TENDER ADDENDUM**Temporary Agriculture Storage Dome****NCC tender file # AL1587****May 15, 2015****ADDENDUM NO: 2****ADDENDA À LA SOUMISSION****Entrepôt temporaire de style dôme agricole****Dossier de soumission de la CCN no. AL1587****Le 15 mai 2015****ADDENDA NO: 2**

Rideau Hall - TEMPORARY Agriculture Storage Done
NCC Tender file : AL1587

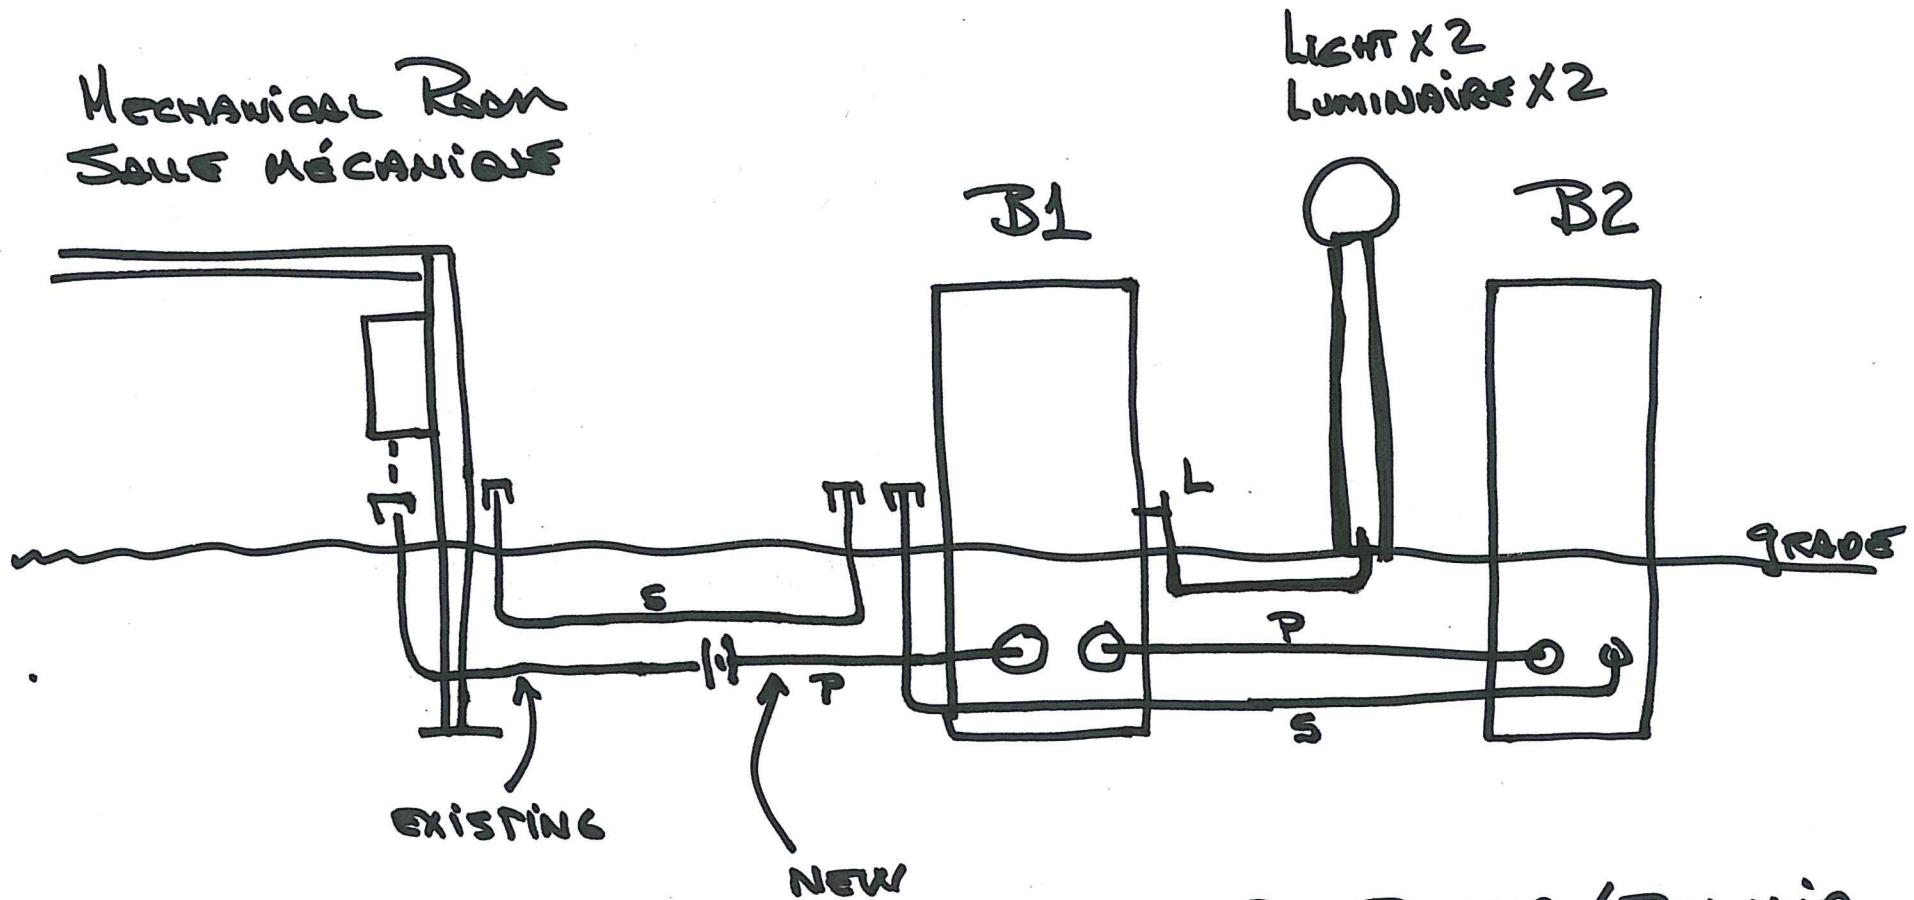
Q1- The extra conduit that is to be ty-in to first bollard already as 2 conduits as shown on drawing E2 (one to lamppost, second from existing 120/208 panel). How we are going to terminate this new conduit at the first bollard.

Q1 – Le conduit supplémentaire qui doit être branché au premier piédestal a déjà 2 conduits tels que démontré au dessin E2 (un au lampadaire, le deuxième à la source panneau 120/208). De quelle manière devons-nous installé ce nouveau conduit au premier piédestal?

A1 – See attached sketch

R1- Voir croquis ci-joint.

Mechanical Room Salle Mécanique

P = POWER / Pouvoir

S = SPARE / LIBRE

L = LB FITTING FOR LIGHTS
RACCORD LB POUR LUMIÈRE
